UNITED STATES PATENT AND TRADEMARK OFFICE

APPLICATION NO.	FILING DATE	FIRST NAMED INVENTOR	ATTORNEY DOCKET NO.	CONFIRMATION NO.
09/992,941	11/05/2001	Ira Jeffery Bush	OPTI-0008	9187

Office Action Summary	Application No. 09/992,941	Applicant(s) BUSH, IRA JEFFERY	
	Examiner Samuel A. Turner	Art Unit 2877

DETAILED ACTION

Figure 15. All-Fiber Autocorrelator With Wavelength Reference

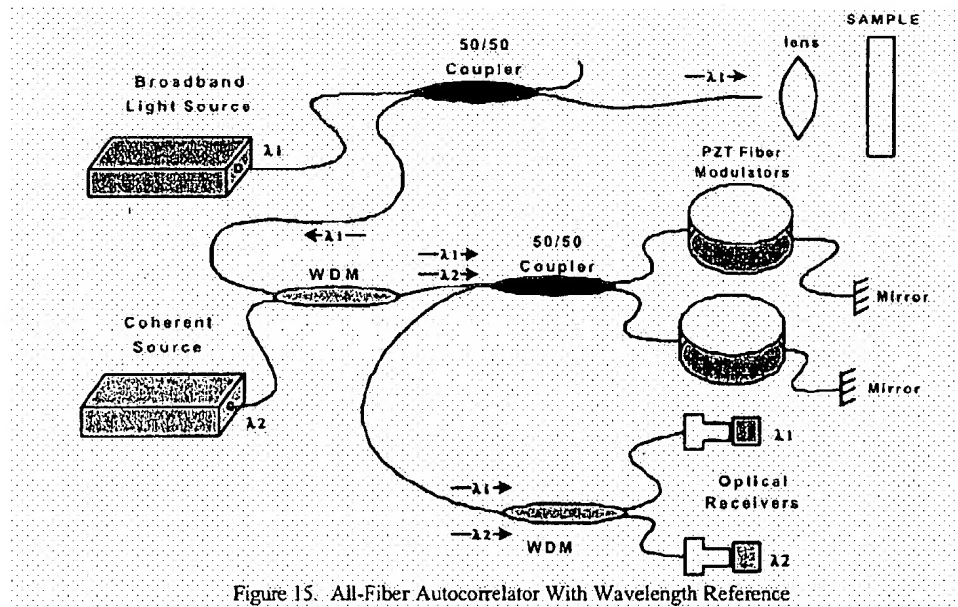
Claims 1,2, and 6-20 are rejected under 35 U.S.C. 102(b) as being clearly anticipated by Bush et al(SPIE). Please note figure 15 and the common inventor Bush.

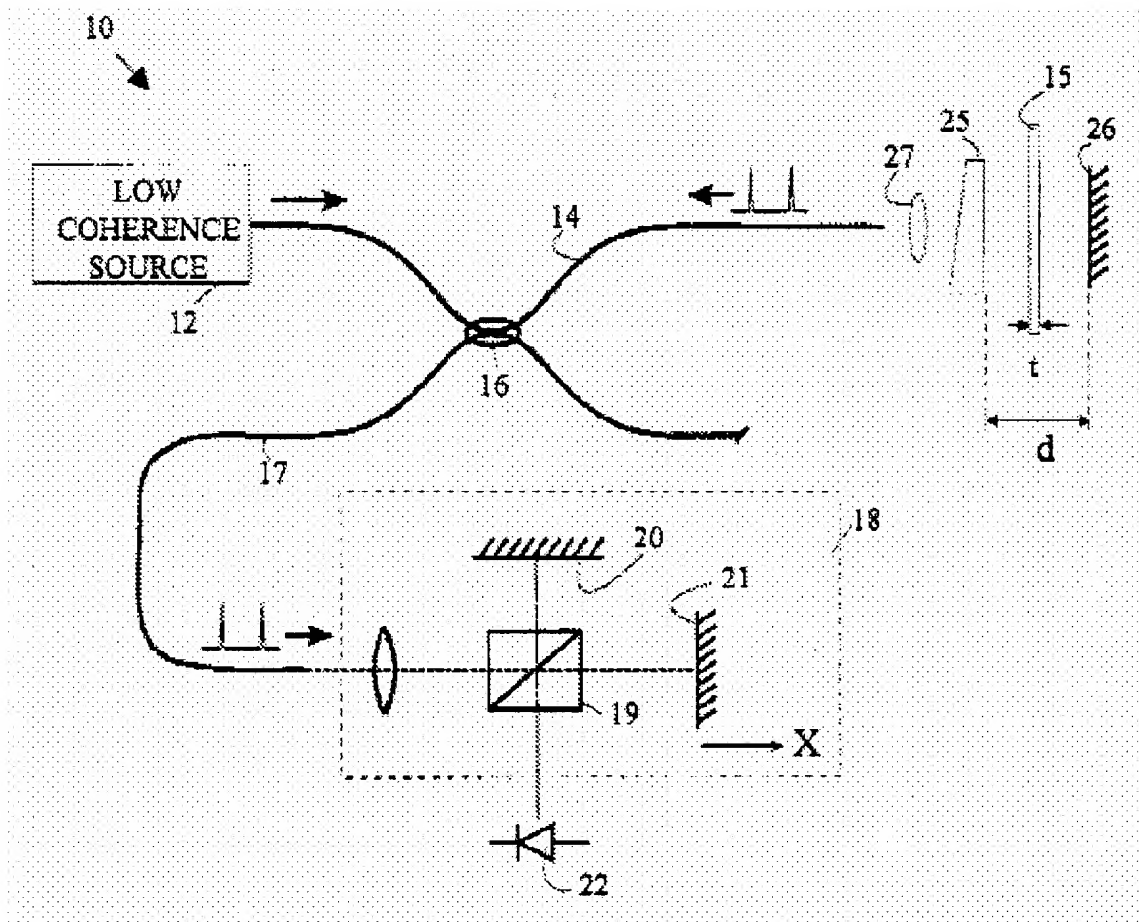
Venkatesh et al teach a fiber low coherence reflectometer autocorrelator comprising a low coherence source(12), fiber probe(14) with a focusing lens(27), and a bulk optical Michelson interferometer which acts as an autocorrelator. The

autocorrelator includes a beam-splitter(19), reference mirror(20), scanning mirror(21), and detector(22). An all fiber autocorrelator is not shown by Venkatesh.

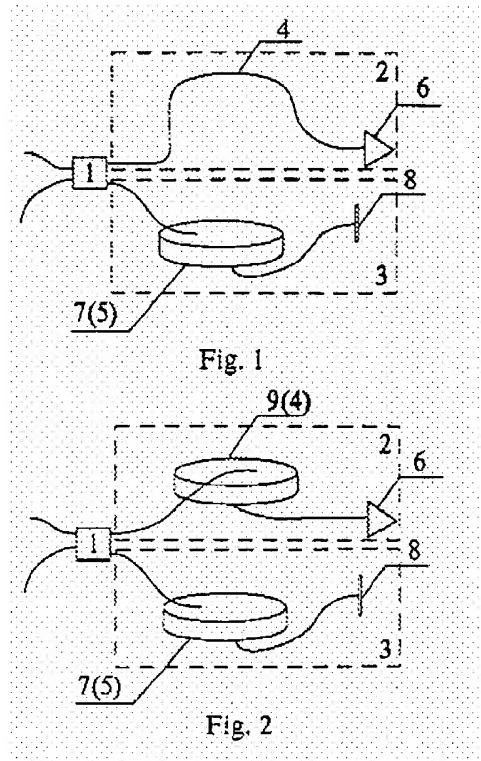
Gelikonov et al teach an all fiber low coherence interferometer comprising a low coherence source, first coupler(1), first fiber(4), probe(6), second fiber(5), reference mirror(8), and a detector. Piezoelectric modulator(7) is included to scan the optical path thus providing a practically inertialess path change. A second piezoelectric modulator(9) can be placed in the opposite arm of the interferometer connected in antiphase (a push/pull configuration) to further increase the total scan length.

It would have been obvious to one of ordinary skill in the art at the time the invention was made to replace the bulk optical autocorrelator Michelson interferometer of Venkatesh with an all fiber Michelson interferometer so that the scanning mirror would be replaced with the fiber piezoelectric modulator scanner which provides for a practically inertialess path change.

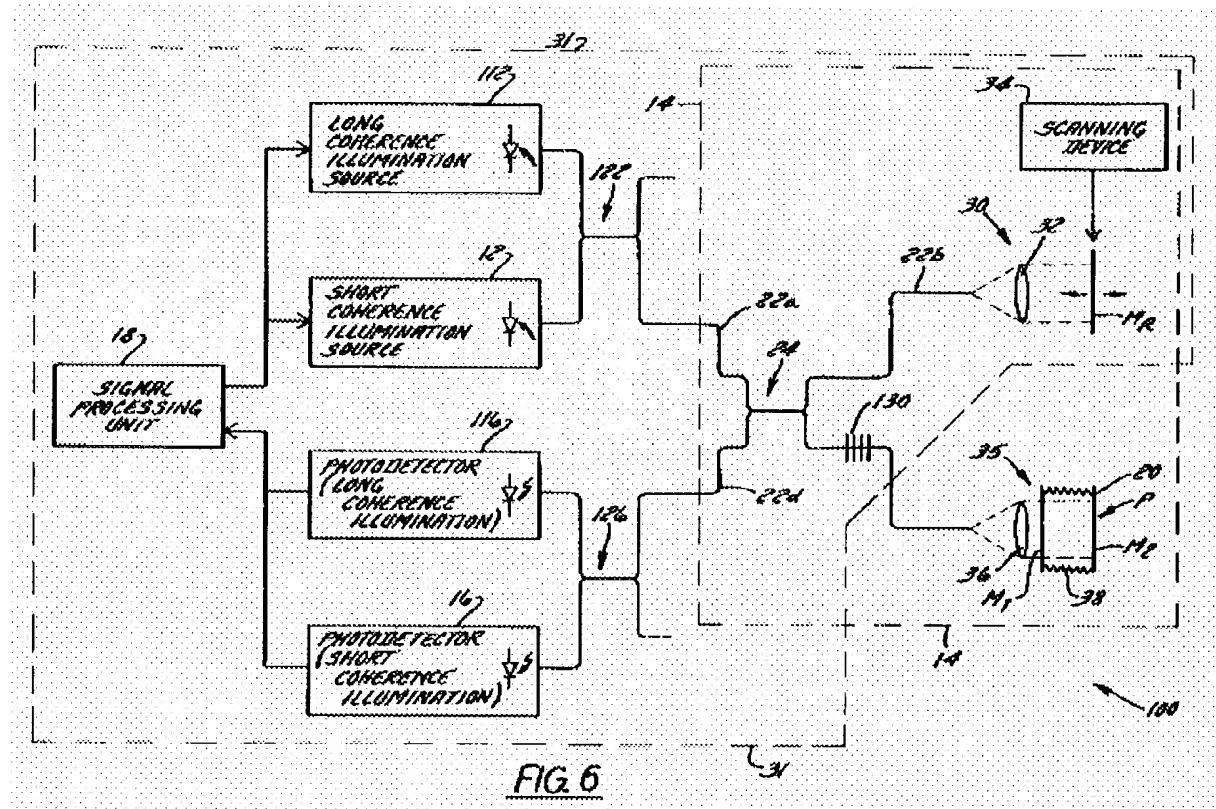
Kempen et al teach a low coherence Michelson interferometer comprising a short coherence source(12), first fiber(22a), coupler(24), reference path(22b), scanning mirror(M_R), probe arm(22c), probe assembly(35), combined path(22d), and detector(16). Also included in the interferometer is long coherence source(112), coupler(122) for coupling the long coherence light to the Michelson interferometer, dispersive coupler(126) for separating out the long coherence light combined light path, and detector(116). The addition of the long coherence source and detector is to track the path change due to the scanning mirror.

It would have been obvious to one of ordinary skill in the art at the time the invention was made to modify an all fiber autocorrelator by including a separate long coherence source and detector in order to monitor the scanned path length, as taught in Kempen.

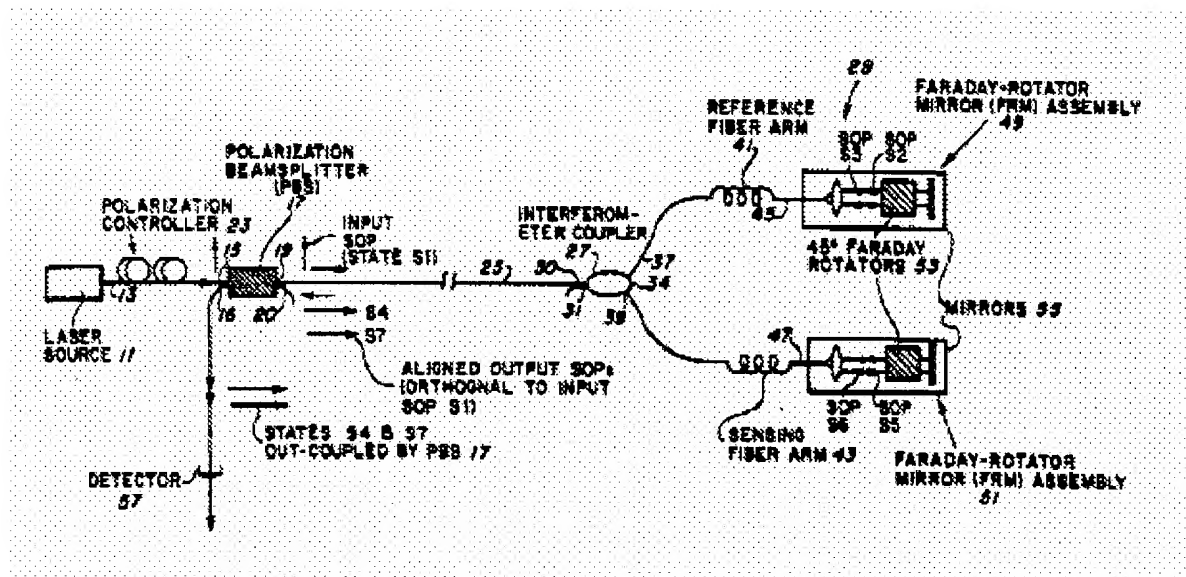
Kersey teaches the use of Faraday rotator mirrors(49,51) in a fiber optical Michelson interferometer in order to provide for passive elimination of polarization fading.

It would have been obvious to one of ordinary skill in the art at the time the invention was made to replace the end mirrors in an all fiber autocorrelator arrangement with Faraday rotator mirrors in order to provide for passive elimination of polarization fading.
